## **ADDENDUM No. 3 TO THE CONTRACT DOCUMENTS**

**Project:** City of Unalaska Lake & River Restoration Projects

**Addendum Issue Date:** December 22, 2015

Replace previously issued project drawings with those attached. This includes sheet numbers 1, 4, 6-18

TITLE:  
GENERAL NOTES (1 OF 2)

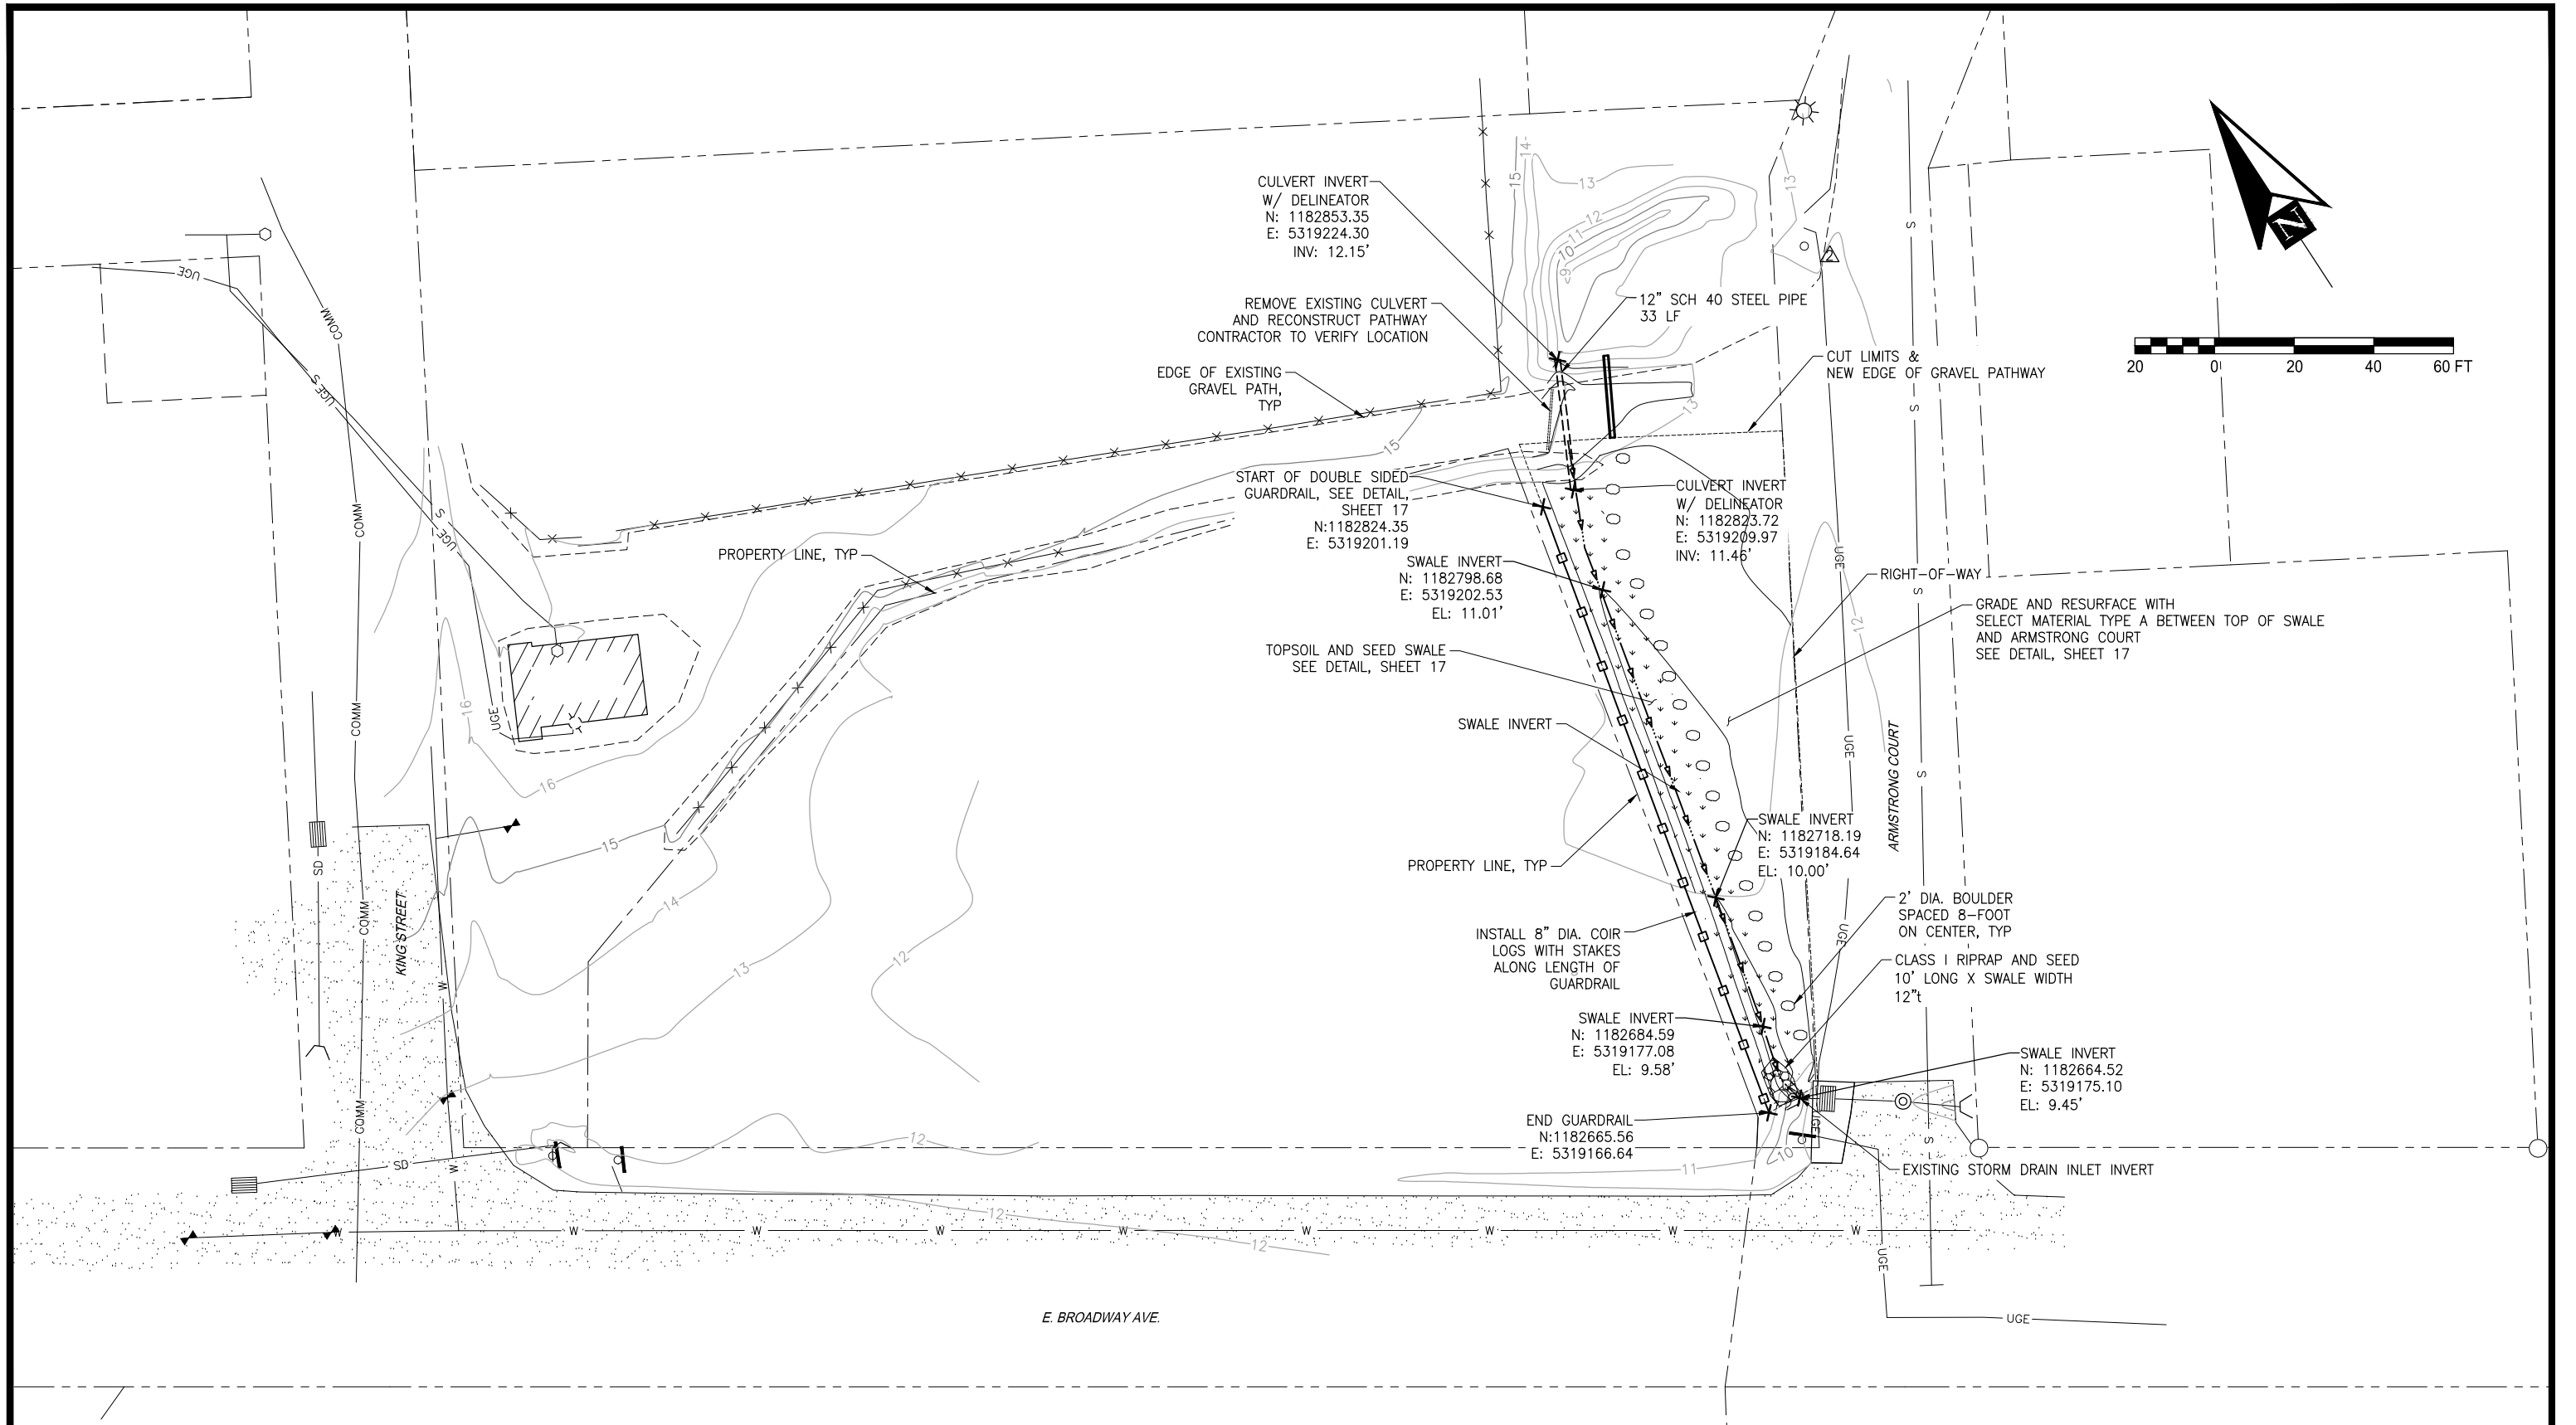
ALL WORK SHALL BE COMPLETED BY MAY 30<sup>TH</sup>, 2016. APRIL 30<sup>TH</sup>, 2016.
